8.1 DA 2010/1061 - Section 96 - 27 Ross Street, Ballina.DOC

CHANGES TO UPPER FLOOR BALCONIES

**NOTICE TO APPLICANT OF DETERMINATION OF A
DEVELOPMENT APPLICATION**

Development Application No: DA 2010/1061

Sheet number	4 OF 4
Scale	1:200
Date	19/06/2014 2:28:26 PM
Drawn by	RVT (A.C.)
Checked by	A.C.
Project number	RVT 3833

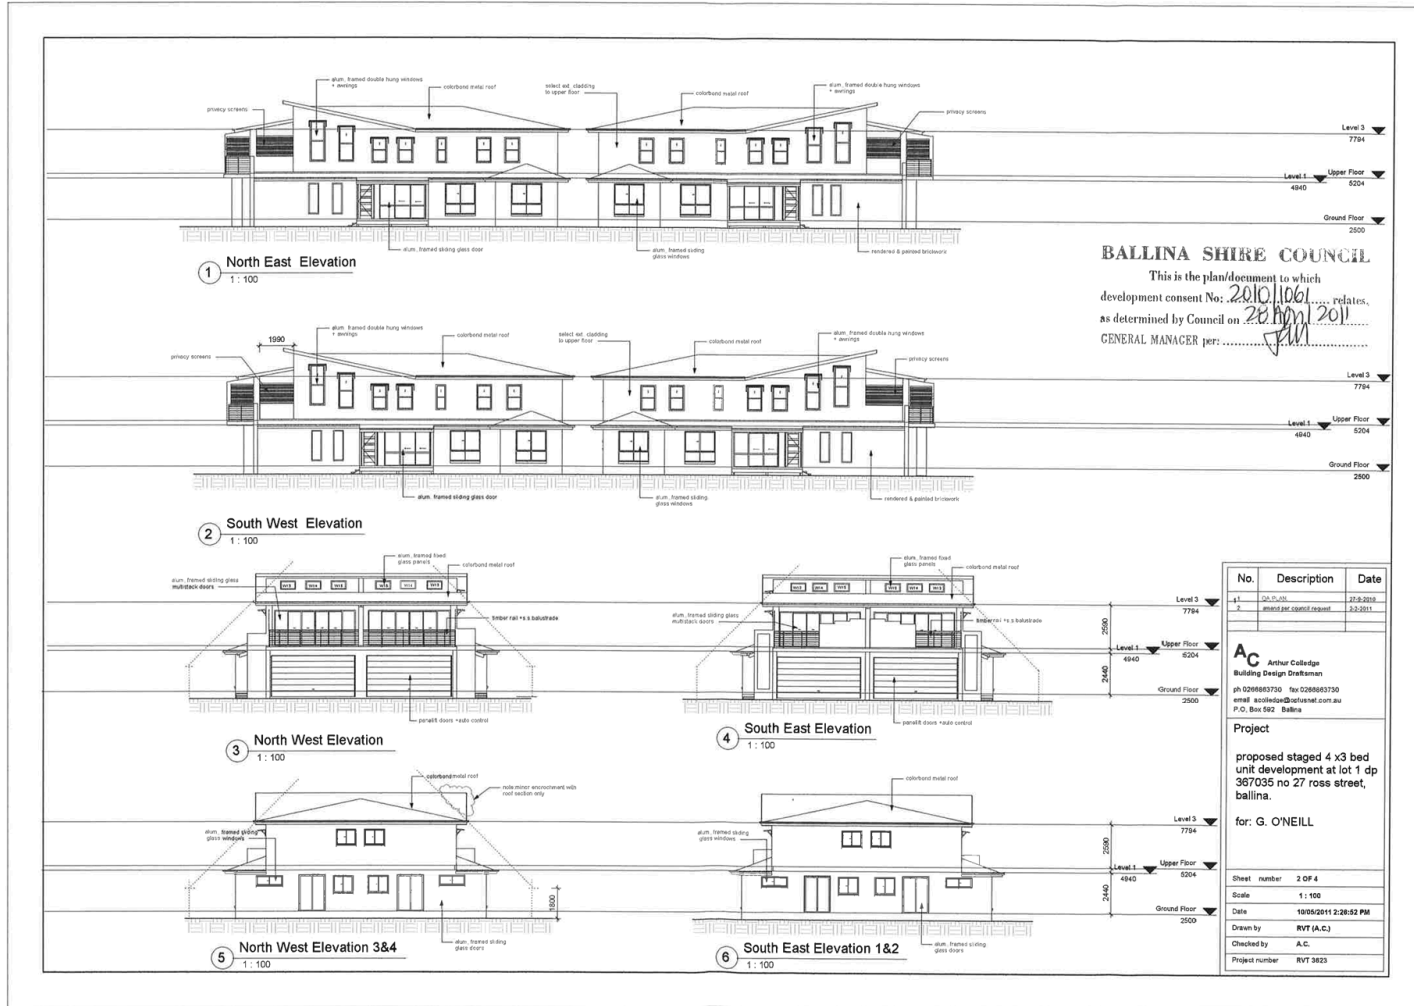
Mr O'Neill has applied for a section 96 Application to modify consent to change construction materials for 1st floor balcony privacy screens on units 3 & 4 from solid screens to wire and balustrade

What the applicant now seeks to do is **not** to change the construction materials, but **delete the privacy screens**. He intends to replace the **1.8m high and 2.7m wide, solid privacy screens looking into my property and my neighbour's properties from both balconies, with a wire balustrade at handrail height, and no privacy screen**. As the building itself has not been changed there is no valid reason to delete the sound and privacy screens at this late stage. The screens were added by the Developer, along with other modifications, prior to the DA being voted on by Councillors at a Council Meeting. The Development was approved because the applicant added these items.

Further to that our intention is to provide glass panel balustrading to the entire balconies which does block sound. The original consent allowed for 2/3 rds of the balconies to be open wire balustrading and only one third in blockwork, so making them entirely of glass will reduce noise and certainly not increase it from the original construction.
